STAFF REPORT
KETCHUM PLANNING AND ZONING COMMISSION
REGULAR MEETING OF MARCH 18, 2026

PROJECT:	680 N Leadville Ave Multi-Family Development
APPLICATION TYPE:	Preapplication Design Review (File No. P25-062)
PROPERTY OWNER:	Plumbum, LLC
REPRESENTATIVE:	Brenda Moczygema, AIA, Williams Partners Architects
REQUEST:	Preapplication Design Review for the development of a new 10-unit multi-family residential building
LOCATION:	680 N Leadville Ave (Ketchum Townsite: Block 27: Lots 3 & 4)
ZONING:	Mixed-Use Subdistrict of the Community Core (CC-2 Zone)
REVIEWER:	Abby Rivin - Senior Planner
NOTICE:	A courtesy notice for the public meeting was mailed to all owners of property within 300 feet of the project site and all political subdivisions on February 25, 2026. The public meeting notice was published in the Idaho Mountain Express on February 25, 2026. A notice was posted on the City's website on March 3, 2026 and on the project site on March 11, 2026. Public comment received prior to publication of the staff report is included as Attachment E.

ROOF PLAN
 SCALE: 1/8" = 1'-0"

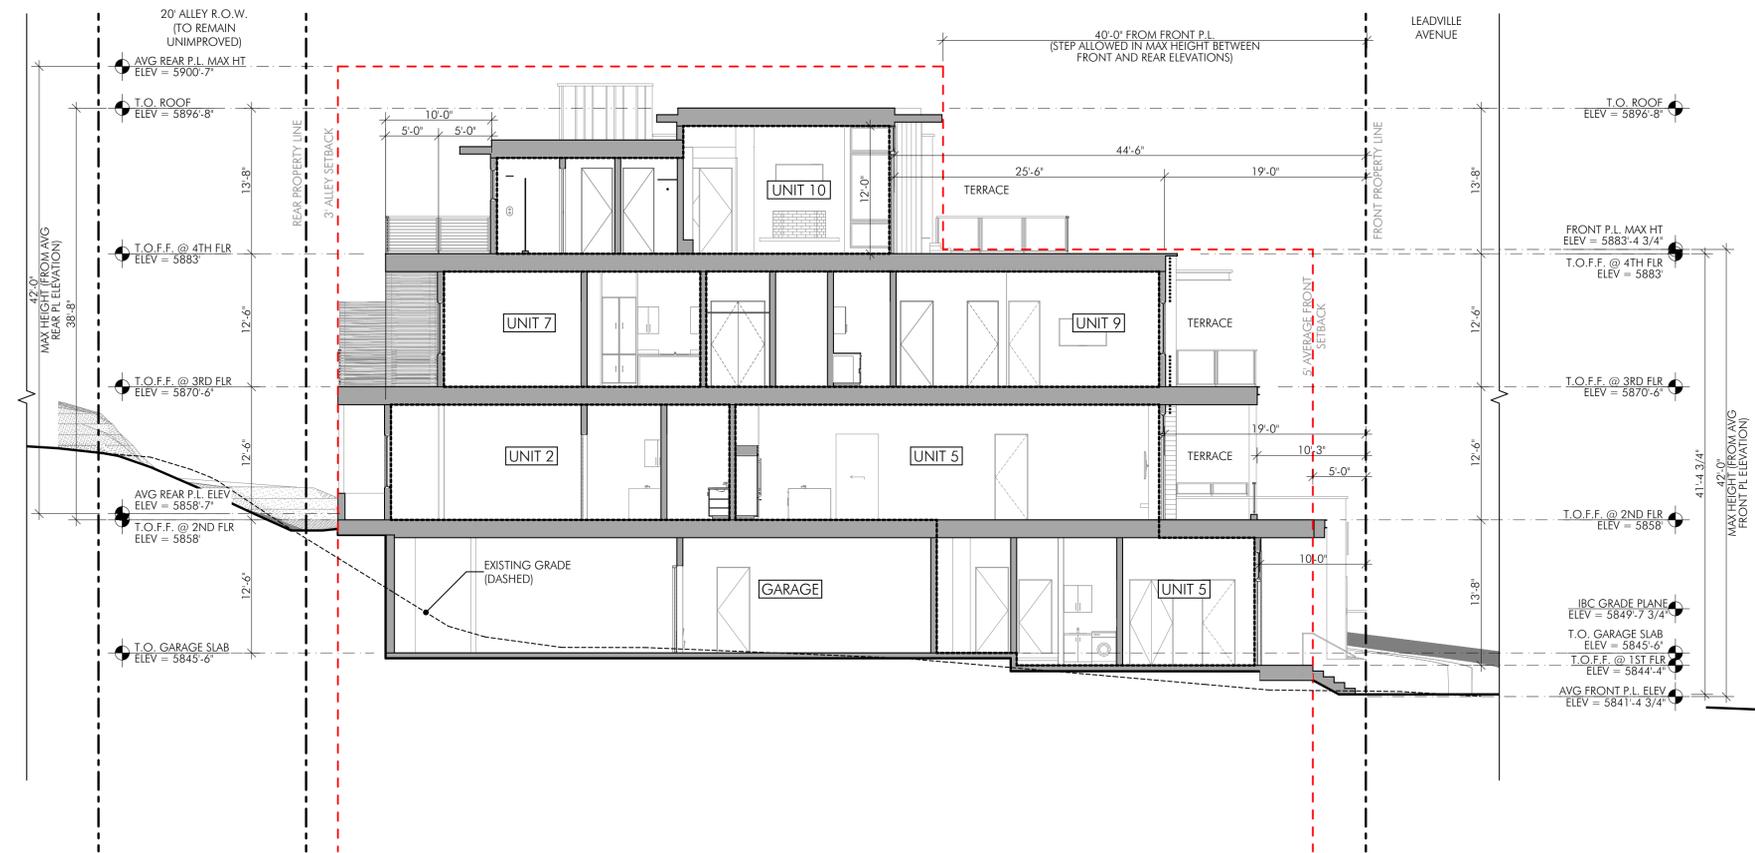
The proposed multi-family development does not include a roof deck. The roof plan on Sheet A2.5 does not indicate any rooftop mechanical equipment. If rooftop mechanical or electrical equipment is proposed, the location and size must be shown on the roof plan submitted with the Final Design Review application.

7. *Rooftop Mechanical Equipment*—The roof plan on Sheet A2.5 does not indicate any rooftop mechanical equipment. Any proposed equipment must be shown on the roof plan. Per KMC §17.12.040, mechanical equipment and solar panels may extend up to 5 feet above the roof surface and must be set back at least 10 feet from all building facades. In addition, roof- and ground-mounted mechanical and electrical equipment must be fully screened from public view with screening compatible with the building design (KMC §17.96.070.C2).
